Our ref: 18180
Council ref: APP-20181676

Environment Southland
Cnr. North Rd and Price
St, Invercargill

Re: Request for Further Information under Section 92(1) of the Resource Management Act 1991 – Application Insert details from s92 request

Figure 1 – Possible bore locations in eastern part of farm, overlaid on ES farm map showing waterways and buffer zones

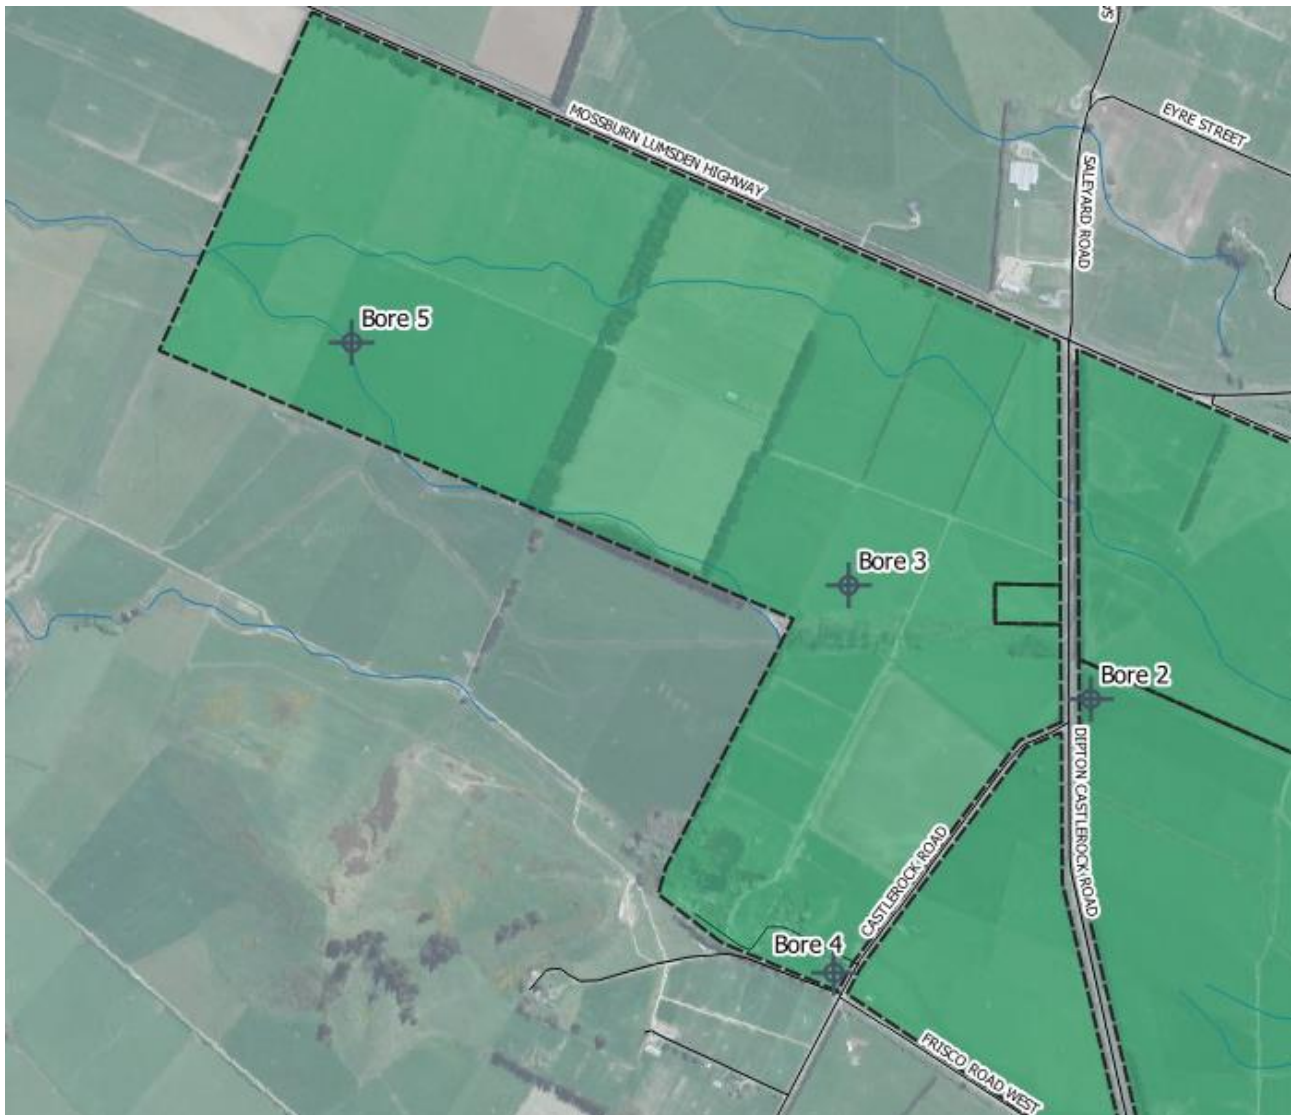
Please provide further details regarding the proposed bore locations in proximity to surface waterbodies including any wetlands, proximity to septic tank outfalls, name of driller and method of construction.

Figures 1 and 2 show the approximate location of the proposed wells relative to surface water bodies. There are no established wetlands on the site, although there are areas near Murrays Creek (particularly

on the north branch near the eastern site boundary and near the confluence in the south-eastern part of the site), which have been retired from grazing and are being progressively planted with natives. The nearest Regionally Significant Wetlands shown in the Beacon GIS viewer are 10-20 km away and are either upstream or in different catchments.

Most of the proposed bore co-ordinates are more than 50 m from the waterways on site, with the exception of Bores 5 and 7 (each 20-30 m from the relevant waterway). Note that the co-ordinates given are approximate and the actual bore locations are to be within 50 m of those positions. Also, because the water take is from a semi-confined aquifer, the distance to the waterway has only a small influence on stream depletion effects. For example, the maximum stream depletion rate of 1.27 L/s calculated for a distance of 50 m is unchanged to two decimal places when the distance is reduced to 0.1 m.
